From:
Monks Orchard Residents'
Association Planning Officer

Reference:	19/00131/FUL
Application Received:	Thu 10 Jan 2019
Application Validated:	Sun 10 Mar 2019
Address	17 Orchard Avenue Croydon CR0 8UB
Proposal	Revised planning application involving demolition of existing detached house, erection of 3-storey building with further floor of accommodation in roof-space comprising 3 x 1 bedroom flat, 4 x 2-bedroom flats and 1 x 3 bedroom flat, formation of vehicular access and provision of 4 associated parking spaces and refuse storage
Status	Awaiting decision
Case Officer:	Christopher Grace
Consultation Expiry:	Fri 23 Aug 2019
Target Decision:	Sun 05 May 2019

17 Orchard Avenue - Application Amended Drawings - 31st July 2019

Illustration of appropriate recent in-fill and Redevelopment Residential and Housing Densities and actual Residential and Housing Densities in the MORA Post Code Area

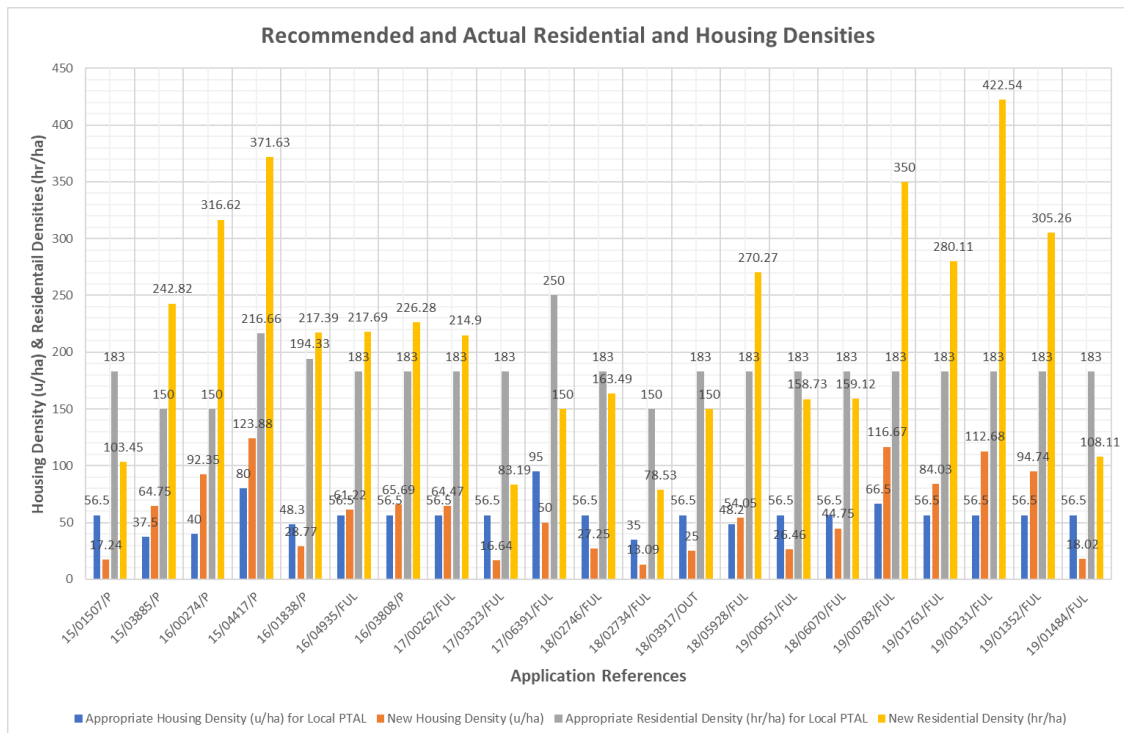
The **appropriate** value for **Residential & Housing Densities** at this “**Suburban setting**” at **PTAL 2** with an average of **3.75 hr/u** are established similarly by: $y = mx + c$

Illustration of excessive PTAL Requirement above the Local available PTAL due to Increased Densities of Applications in the MORA Post Code Area showing the ongoing PTAL linear trend requirement.

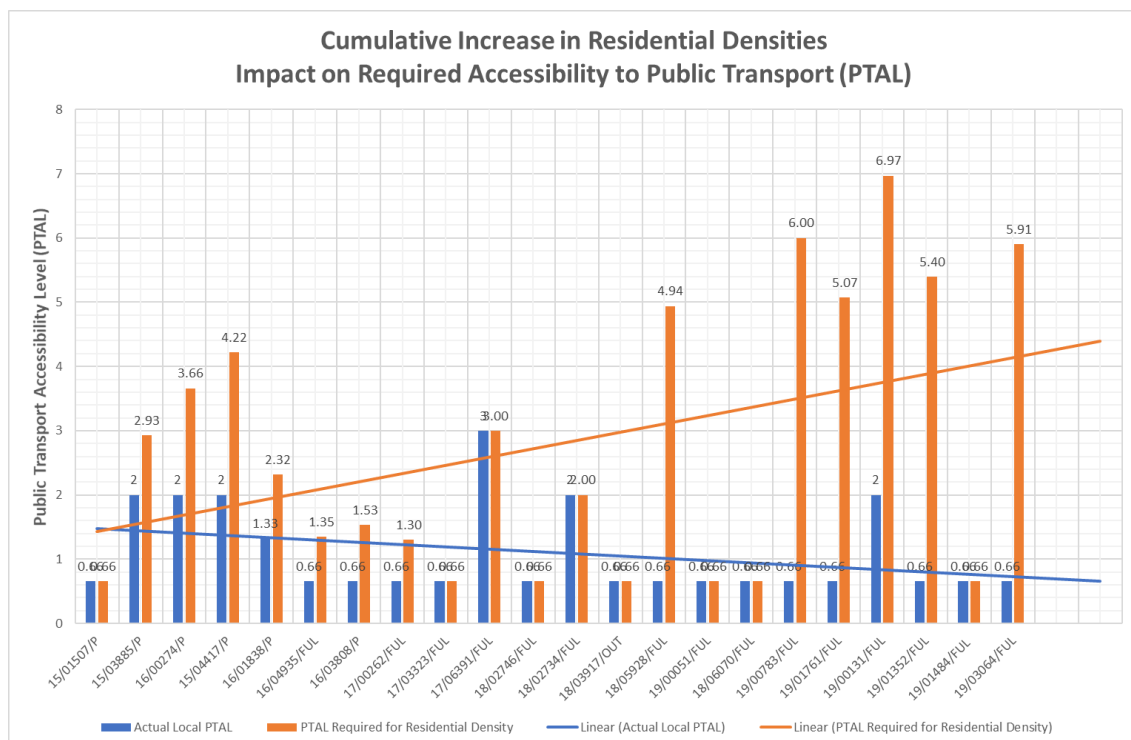
We object to this proposal on grounds of significant overdevelopment for the locality if classified as in a “**suburban setting**” at Residential Density of **422.54 hr/ha** and Housing Density of **112.68 units/ha** at average of **3.75units/ha** development So this proposed development is an **OVERDEVELOPMENT** whether considered a setting of **Suburban or Urban** locality.

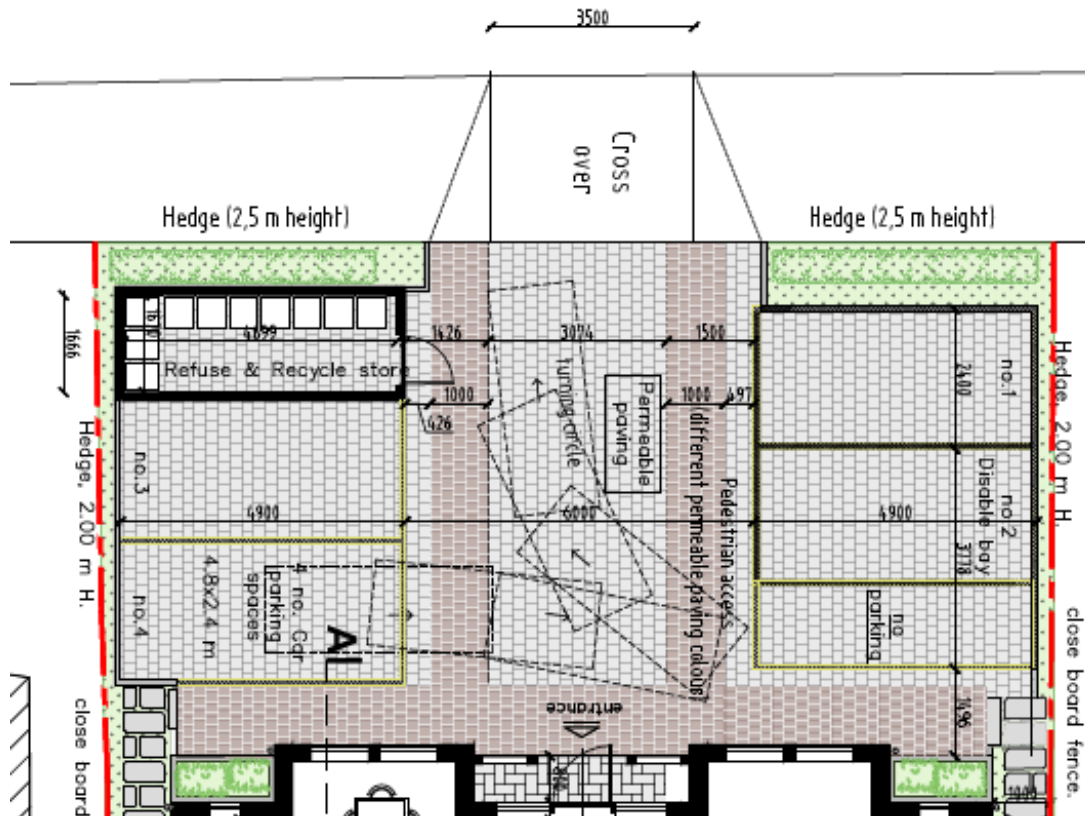
The parking provision is all on the **forecourt** of the proposed development which is contrary to **Policy DM10.2** although screened by 2.5m hedging to meet the policy requirement.

The Swept path diagrams illustrate ingress and egress for a vehicle in bay #4 and the use of the no parking zone adjacent to the disabled parking bay #2 for clearance to assist the manoeuvre.

There are no examples of swept paths for bays #1, #2 and #3 which, if entered in a forward gear, if all other bays were full, would be extremely difficult to exit after reversing within the forecourt and to exit the forecourt in a forward gear.

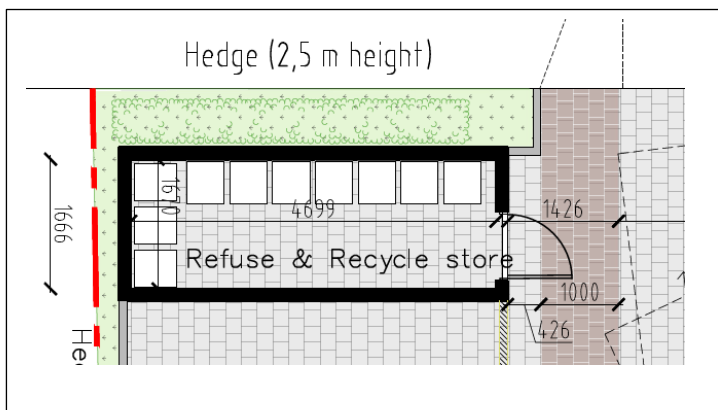
There is no specified allocation of recycling storage for any kitchen of the 5 Units shown on the supplied plans.

It is understood that there must be a minimum of **150mm clearance** around and between each bin within a storage area. Where there is more than **one bin** within a storage area, there must be **2m clearance in front of each bin** to enable it to be accessed and safely moved without needing to move any of the other containers. The proposed development provides 1m clearance in front on the bins and does not provide required **2m clearance** in front of the bins to allow safe movement as the total depth is only **1.666m** in total which includes the depth of the bins.

It is also understood that the access doors to the bin storage must **not open outward** over a **public footway or road**, and should **not** cause any **obstruction** to other accesses when in an open position. The proposed development Refuse Storage doors **DO open outwards** and **DO obstruct access to the adjacent parking space**.

The requirement of a water supply, with standard tap fittings, to be available to the bin storage area to enable washing down of the bins, walls and floor, is not shown on the plans.
